S16YJ

Subject: S16YJ, Rear Engine Exhaust Cables

Models Affected: Certain 2011-2017 Model Year All American Model School Bus and Non-School Bus

Rear Engine Exhaust Cables

See Sheet 2 for illustration

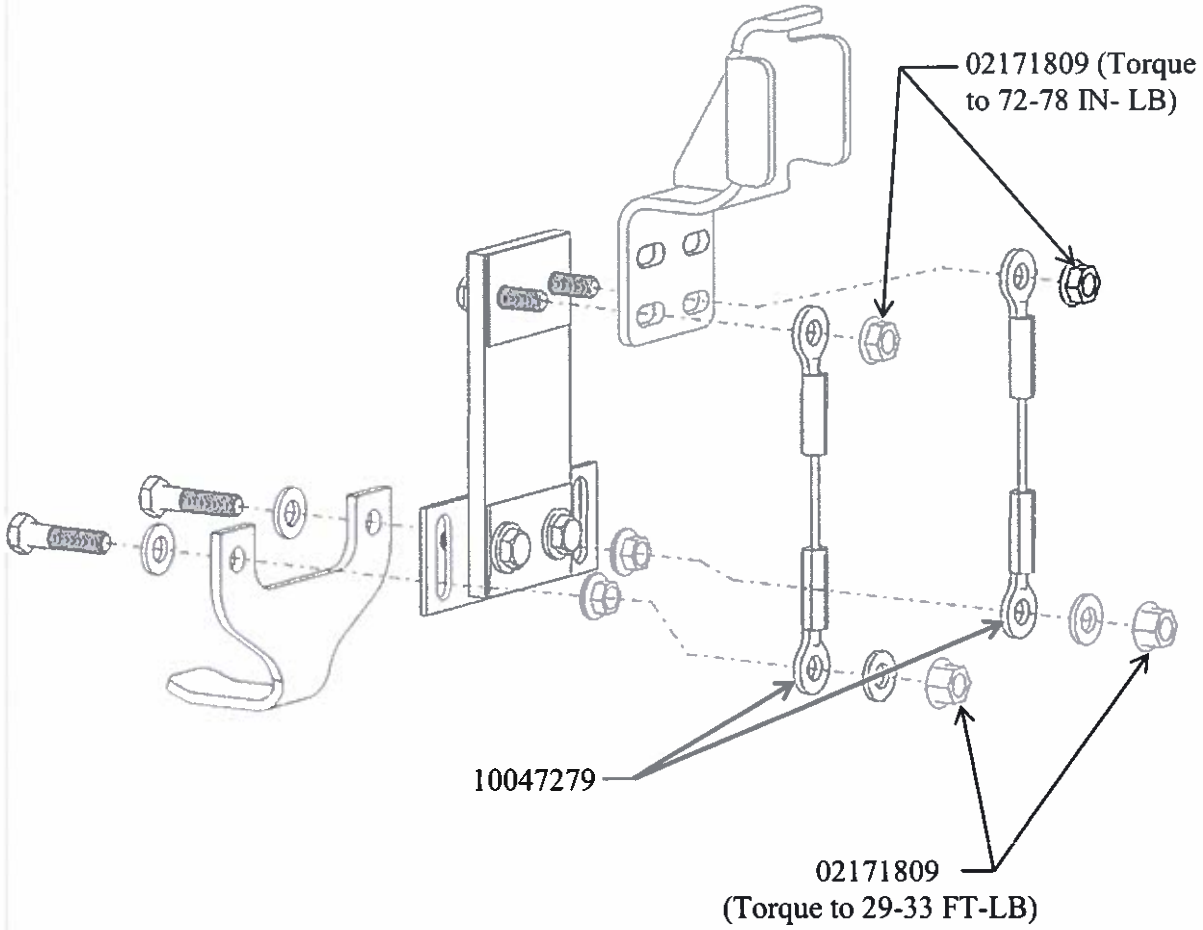
Rear engine exhaust support cables may fail.

Replace existing 5.5 inch cable assembly with new 6.0 inch cable assembly 10047279.

1. Park the bus on a level surface, apply parking brake, turn off engine, remove ignition key, and chock wheels.
2. Locate the four muffler hanger strap assemblies supporting the SCR and DPF at the rear of the bus.
3. Support the SCR and DPF, and replace the eight (8) 5.5 inch exhaust support cable assemblies with eight (8) 6.0 inch exhaust support cable assembly 10047279. Replace each cable assembly by removing the nut at the top of the cable assembly and the nut and washer at the bottom of the cable assembly. Discard old nuts, DO NOT reuse. Remove and discard the 5.5 inch cable assembly. Install the new 6.0 inch cable assembly and new nut at the top and new nut and washer at bottom.
4. Torque upper 3/8" nut to 72 – 78 in-lb. Toque lower 3/8" nut to 29 - 33 ft-lb.
